Office Action Summary

10/675,091

DETAILED ACTION

Claims 1 and 14-20, are rejected under 35 U.S.C. 103(a) as being unpatentable over Evard et al. (US 6616675) in view of Park et al. (US 2003/0120292).

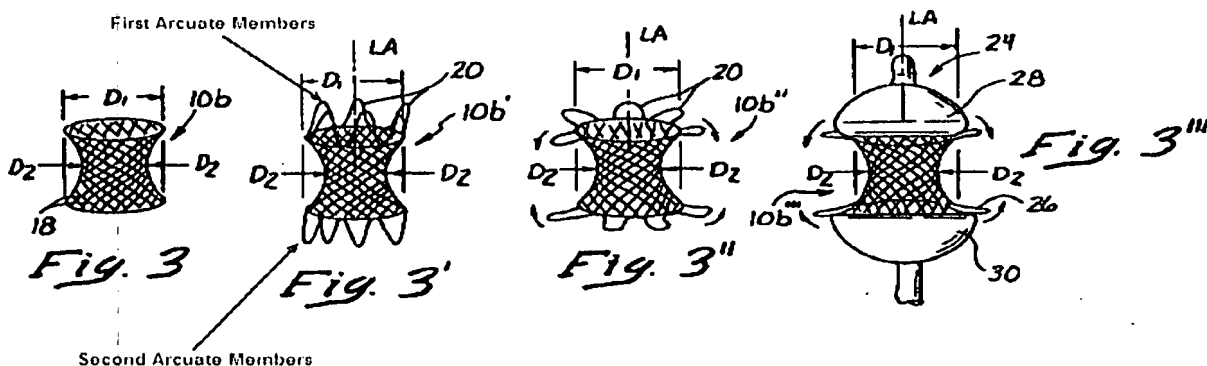
Evard teaches an anastomosis device, comprising the following:

a first plurality of arcuate members (see figure below) arranged in a first position in a cylindrical crown shape; and a second plurality of arcuate members arranged in a first position in an inverted cylindrical crown shape (see figure below) and connected by the connecting member (D₂) to a leg of an arcuate member of the first plurality (fig. 3'); wherein the legs of the arcuate members of the first plurality are attached to the respective arcuate member of the second plurality by a connecting member (D₂). Wherein the legs of the arcuate members of the first plurality are attached to the respective arcuate member of the second plurality by a rigid connecting member (Column 2, proximate lines 63-65), a petal formed by the first arcuate member actuating

generally in a plane with the respective attached arcuate members pivoting about a cylindrical midpoint of the anastomosis device (fig. 3''); and wherein the woven tube thus formed is operably configured to transform into a second position comprising a hollow rivet shape (fig. 3''') with each arcuate member outwardly deflected from a longitudinal axis of its respective cylindrical crown toward apposing arcuate members of the other cylindrical crown.

Wherein the connecting member comprises a band (D_2) at a midpoint of the device connected to each arcuate member (fig. 3')
